Stair flip study · the main stair turned round: start and arrival at the NORTH end, next to the lift · Taif / Palm House V8.0 (work) · STUDY ONLY

ADOPTED 2 Nov 2026 (owner): option B, the freed landing as F-b, the balustrade, the store door onto the riwaq, the half-landing window, the entrance side light, the entry cupboard removed; applied to the design files. Owner's idea, 1 Nov 2026 · the same well (2.75 × 5.7 on axes, 2.525 × 5.50 clear), the same 22 risers × 0.164 / goings 0.28, flights 1.21 clear · nothing in the design files changes until the owner decides · all sizes assumed

1 · The two options on the ground floor

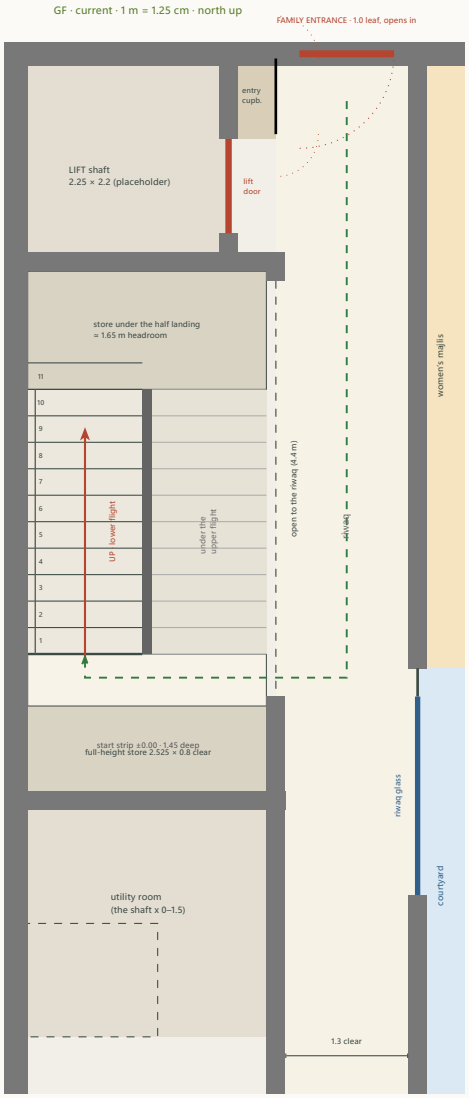
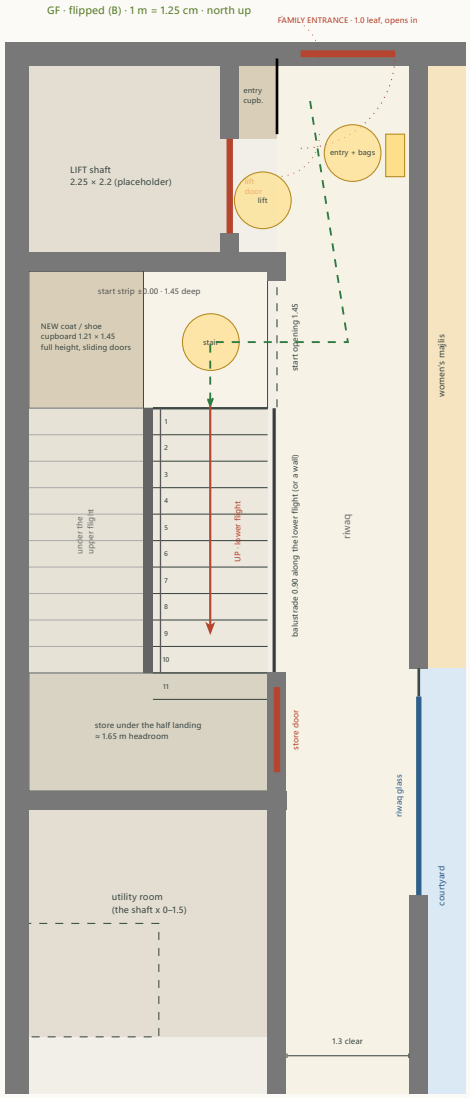
- **Current:** the lower flight on the **west** half starts at the **south** end (first riser y 6.35); the person comes along the riwaq, enters the well through its open east side (4.4 m open) and turns west onto the flight; in front of the first riser only **0.55 m** before the full-height store's wall (the start is really made from the side, under the upper flight's high end). Half landing at the north end (+1.80, a 1.65 m store below it, opening east onto the riwaq); the full-height store 2.525 × 0.8 clear at the south end.

- **Flipped (B, recommended of the two flips):** the lower flight on the **east** half starts at the **north** end (first riser y 3.75), **straight off the lobby**: a 1.45 m opening in the x 2.75 line between the lift notch and the flight, a start strip 1.45 m deep in front of the first riser. The lower flight rises along the riwaq side (a 0.90 balustrade on the riwaq, or a wall: the owner's choice); the half landing at the south end with its 1.65 m store (door onto the riwaq at y 6.7–7.6, in front of the courtyard glass; or into the utility room). The **west half of the start strip** (1.21 × 1.45, full height) becomes a **coat / shoe cupboard** beside the family entrance (sliding doors onto the strip).

- **Flipped (A):** the mirror image only (the lower flight stays west): the person crosses the whole strip to the far half before climbing; no cupboard. Not recommended; everything else below holds for both.

2 · Congestion test at the flipped start (drawn)

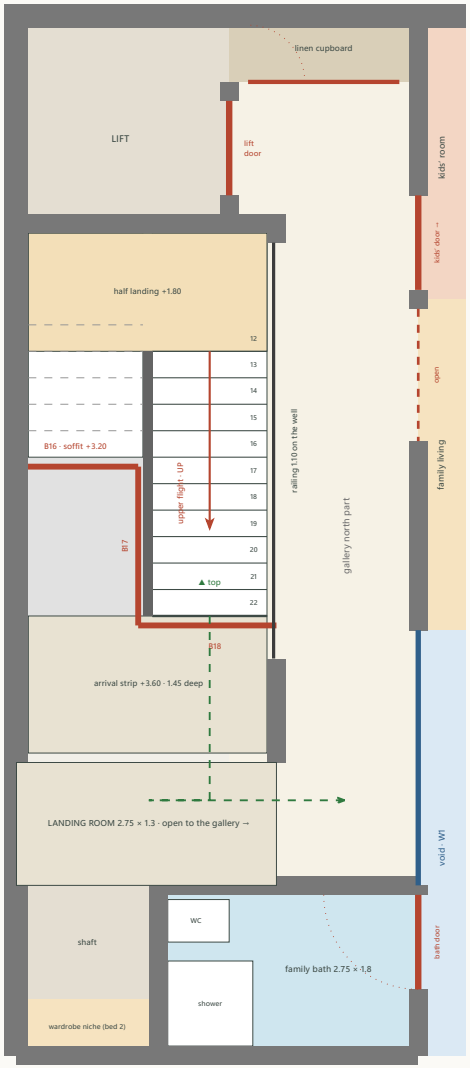
Three people at once: **one waiting for the lift** in the 0.50 m notch in front of its sliding door, **one coming in with bags** inside the family entrance's 1.0 m swing, **one starting up the stair** on the start strip, with the **entry cupboard's two 0.45 leaves open** into the lobby. Clear widths, not axes: the lobby **1.3 m** between the lift / cupboard wall face and the women's majlis wall face (the notch adds 0.5 m at y 0.9–2.2); the start opening **1.45 m**; the first riser **1.21 m** wide; the entrance **0.9 m** clear. The three stand in three separate zones along the lobby (y 0–1.0 the door swing, y 0.9–2.2 the lift notch, y 2.3–3.75 the start strip); the stair starter passes 0.3 m south of the lift waiter and never crosses the entrance swing: **OK**. Two people can pass in the 1.30 m lobby (0.60 + 0.60 + 0.10) but a person with two bags blocks it for a moment, as today. **Furniture up the stair:** the 90° turn from the 1.30 lobby through the 1.45 opening onto the 1.21 flight is a tight but normal house stair turn; the current start (0.55 m strip, sideways) is worse.

FF · current · 1 m = 1.25 cm · white = opening · grey = slab

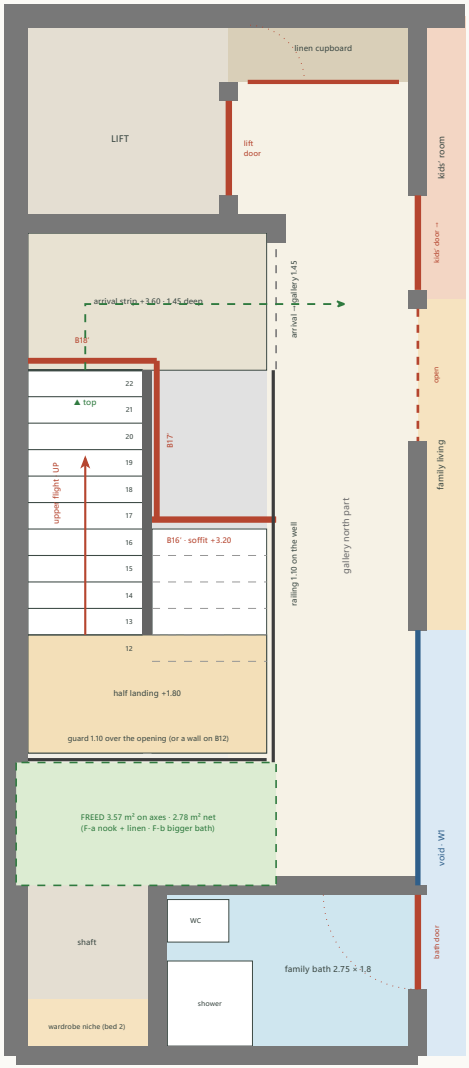
- **Current:** the upper flight (east half) lands at +3.60 on the arrival strip (y 6.35–7.8), then the **landing room** (2.75 × 1.3, y 7.9–9.2) and east into the gallery; the bedrooms and the family bath are at hand, the kids' room, the living and the lift are 6–9 m north along the gallery.

- **Current (studies/structure.typ):** an L-shaped opening ≈ 8.2 m²: the west half open from the north wall to B16 (y 4.85), the east half open to B18 (y 6.45); B16 (0.20 × 0.40, soffit +3.20) from the west wall to B17; B17 (x 1.29, on the lower flight's side of the split) from B16 to B18; B18 (y 6.45) from B17 to the riwaq-line beam B10 (x 2.75).

FF · flipped (B) · 1 m = 1.25 cm · white = opening · grey = slab

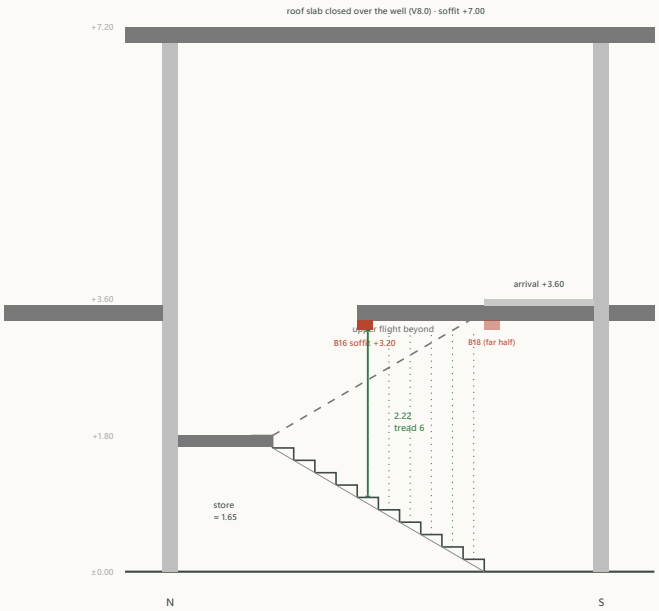
- **Flipped (B):** the upper flight (west half) lands on the arrival strip at the **north** end (y 2.3–3.75); the strip opens east onto the gallery's north part (1.45 m), **0.10 m south of the lift notch**: the lift's first-floor door, the linen cupboard (its leaves swing south, 0.6 m), the kids' room door (opens into the room) and the family living's opening are all within 1–3 m. The gallery's north part (1.30 clear) carries the arrival traffic as it carries the lift's today; the linen leaves and the lift door are 1.0 m north of the arrival: no clash. The railing on the well runs from the arrival (y 3.75) to the south wall; the landing room is **freed** (§ 5).

- **Flipped (B):** the **same opening turned round** (≈ 8.2 m²): the east half open from B16′ (y 5.33) to the south wall, the west half from B18′ (y 3.65) to the south wall. **B16′** (y 5.33) from the riwaq-line beam B10 to B17′; **B17′** (x 1.49, on the east, lower flight's side of the split: never over the upper flight) from B16′ to B18′; **B18′** (y 3.65, the arrival edge) from the west wall to B17′. The same zigzag, mirrored: one beam-on-beam junction at each end of B17′, the torsion the engineer's; B18′ now bears on the west wall (as B16 does today) and B16′ on B10 (as B18 does today). **Neither better nor worse** for the structure: the spans (1.3–1.6 m) and the bearings are the same kind. **Not verified.**

- **Slab edges:** the arrival strip (1.45 × 2.525) spans between the north wall beam B11 (y 2.2) and B18′; over the lower flight's first six treads the slab spans from B18′ to B16′ (1.6 m) between B10 and B17′. The guard round the opening: the railing on x 2.75 from the arrival south to y 7.9, the well's south wall line y 7.9 (a 1.10 guard or a wall on B12), the upper flight's balustrade on the split.

Headroom · a section along the lower flight for each option · the slab 0.2 thick (soffit +3.32), the trimmers 0.20 × 0.4 (soffit +3.20), the finish 0.08 · over the full walking width of every tread

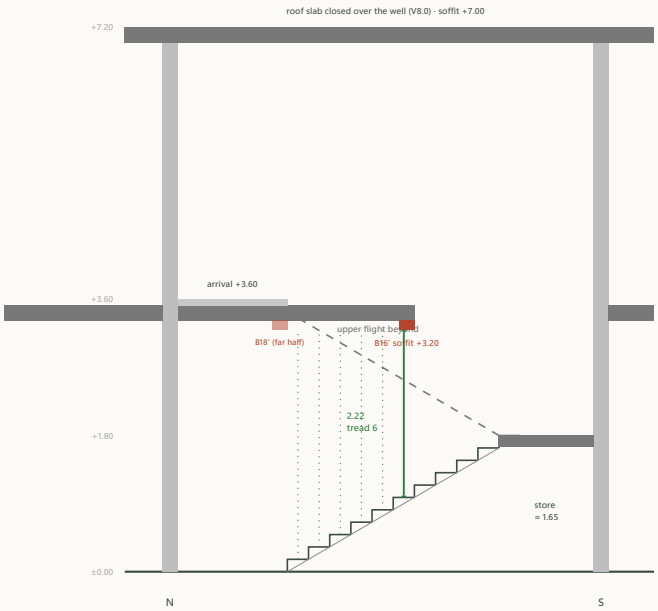
The upper flight, the half landing and the arrival are under the open well (the roof slab's soffit +7.00): ≥ 3.4 m. Minimum of this option: **2.22 m** at tread 6 under the trimmer, across the whole 1.21 m width (the trimmer spans the half); B17 over the inner 0.10 strip of treads 1–5: ≥ 2.38 m.

The upper flight, the half landing and the arrival are under the open well (the roof slab's soffit +7.00): ≥ 3.4 m. Minimum of this option: **2.22 m** at tread 6 under the trimmer, across the whole 1.21 m width (the trimmer spans the half); B17′ over the inner 0.10 strip of treads 1–5: ≥ 2.38 m.

Verdict on the headroom: identical in both options (**2.22 m** at tread 6 under the trimmer, 2.83 m at tread 3 under the slab; ≥ 2.10 required, the 2.20 aim just met) because the flip mirrors the geometry: the trimmers sit in the same places relative to the treads. **The flip neither improves nor worsens the trimmers.** What would improve both: trimmers 0.20 × **0.30** (soffit +3.30 → **2.32 m** at tread 6) if the engineer accepts a 0.30 depth for the 1.3–1.6 m spans, or the slab edge moved one tread (the opening 0.28 m longer, ≈ 0.35 m² more void, tread 6 under open sky → the minimum moves to tread 5: 2.38 m). Both options can take either. The walls' handrails run the full flights (0.08 off the walls); the central handrail on the 0.10 split.
